SUBJECT: RIVER BEND STATION, UNIT 1 - STAFF ASSESSMENT OF INFORMATION PROVIDED PURSUANT TO TITLE 10 OF THE *CODE OF FEDERAL REGULATIONS* PART 50, SECTION 50.54(f), SEISMIC HAZARD REEVALUATIONS FOR RECOMMENDATION 2.1 OF THE NEAR-TERM TASK FORCE REVIEW OF INSIGHTS FROM THE FUKUSHIMA DAI-ICHI ACCIDENT (TAC NO. MF3706)

STAFF ASSESSMENT BY THE OFFICE OF NUCLEAR REACTOR REGULATION

RELATED TO SEISMIC HAZARD AND SCREENING REPORT

RIVER BEND STATION, UNIT 1

Figure 3.3-1 Plot of Staff's and Licensee's Base Case Shear-Wave Velocity Profiles for the RBS Site

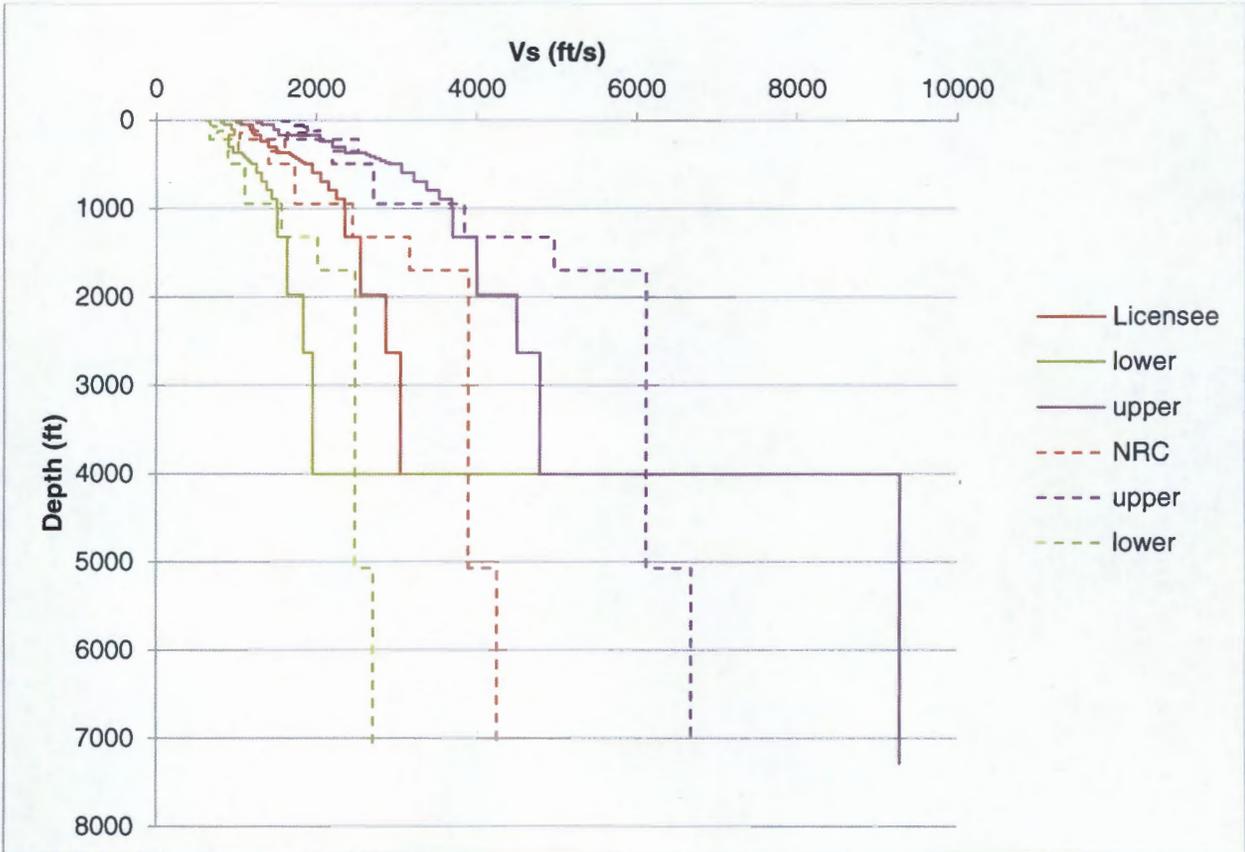
200 ft (61 m) of its base case shear wave velocity profile, the NRC staff used the data provided in UFSAR Table 2.5-10. The NRC staff extended its base case velocity profile to a depth of about 1000 ft (305 m) using COL data and then used the generic gradient recommended in the SPID to extend the profile to a depth of 7000 ft (2,134 m). To develop the upper and lower base case velocity profiles, the NRC staff used a natural log standard deviation of 0.2. Figure 3.3-1 of this assessment shows a comparison of the three base case velocity profiles developed by the licensee with those developed by the NRC staff. The profiles developed by the licensee are similar in shape to those developed by the NRC staff. However, the staff's profiles extend to greater depth than the licensee's and are generally faster at depths greater than approximately 1,000 ft (305 m).

Figure 3.3- 2 Plot Comparing the Staff's and the Licensee's Median Amplification Functions and Uncertainties for the RBS site.

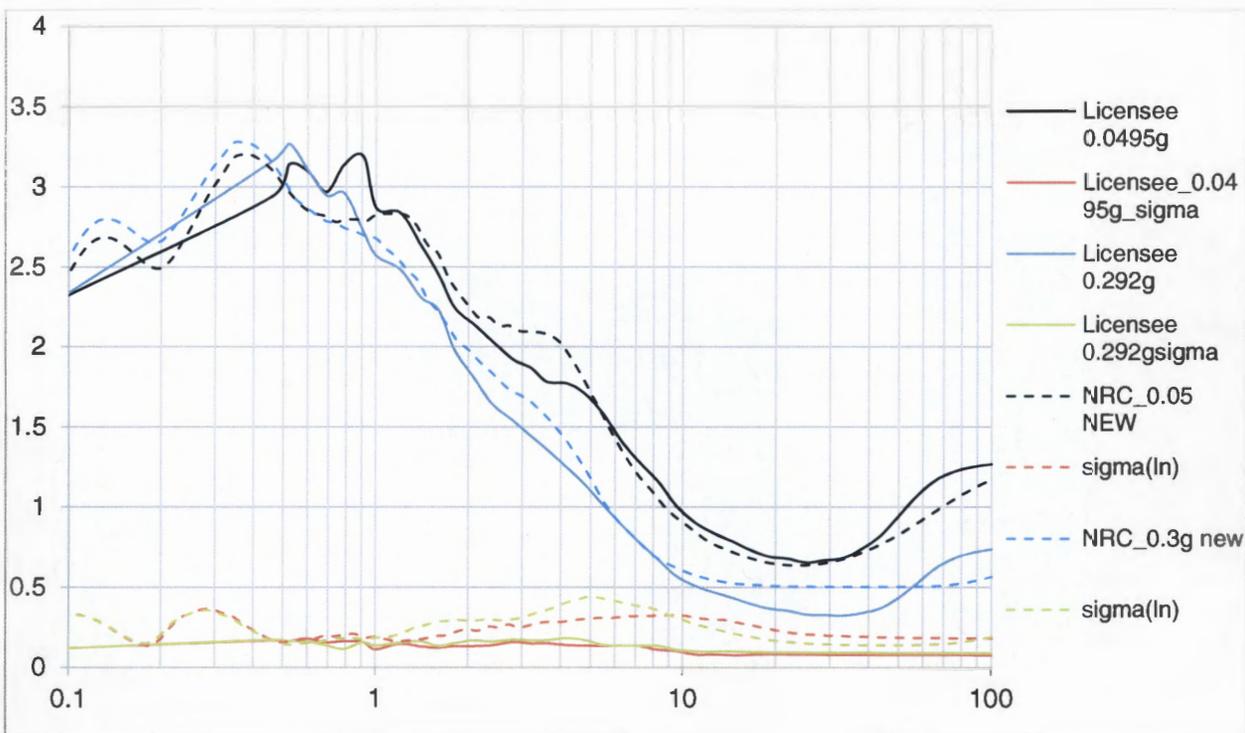
Figure 3.3-2 of this assessment shows a comparison of the staff's and the licensee's median site amplification functions and uncertainties (± 1 standard deviation) for two of the eleven input loading levels. The peak in amplification functions occurs between approximately 0.4 and 1.0 Hz in both the staff's and the licensee's curves. Differences in site amplification curves developed by the NRC staff and the licensee are due primarily to differences in site velocity profiles and are minor. As shown in Figure 3.3-3 of this assessment, these differences in site response have a modest impact on control point seismic hazard curves and the resulting GMRS, discussed below. Appendix B of the SPID provides guidance for performing site response analyses, including capturing the uncertainty for sites with less subsurface data. However, the guidance is neither entirely prescriptive nor comprehensive. As such, various approaches in performing site response analyses, including the modeling of uncertainty, are acceptable for the 50.54(f) response.

Figure 3.4-1 Comparison of the Staff's GMRS with Licensee's GMRS and the SSE for the River Bend Station site

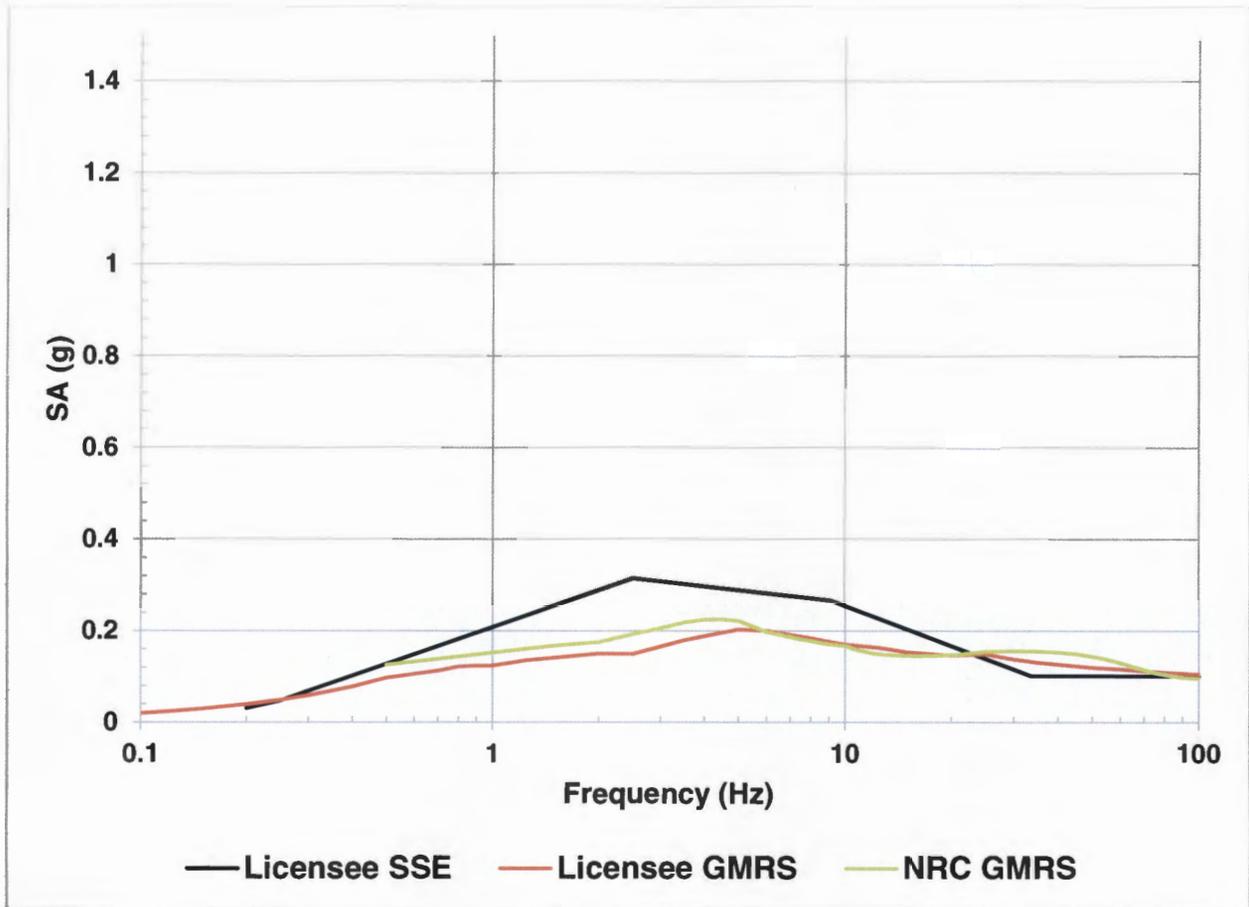
The NRC staff independently calculated the 10^{-4} and 10^{-5} UHRs using the results of its confirmatory PSHA and site response analysis, as described in Sections 3.2 and 3.3 of this staff assessment, respectively. As shown in Figure 3.4-1 below, the licensee's GMRS shape is very similar to that calculated by the NRC staff.

The NRC staff confirms that the licensee used the present-day guidance and methodology outlined in RG 1.208 and the SPID to calculate the horizontal GMRS, as requested in the 50.54(f) letter. The NRC staff performed both a PSHA and site response confirmatory analysis and achieved results consistent with the licensee's horizontal GMRS. As such, the NRC staff concludes that the GMRS determined by the licensee adequately characterizes the reevaluated hazard for the RBS site. Therefore, this GMRS is suitable for use in subsequent evaluations and confirmations, as needed, for the licensee's response to the 50.54(f) letter.
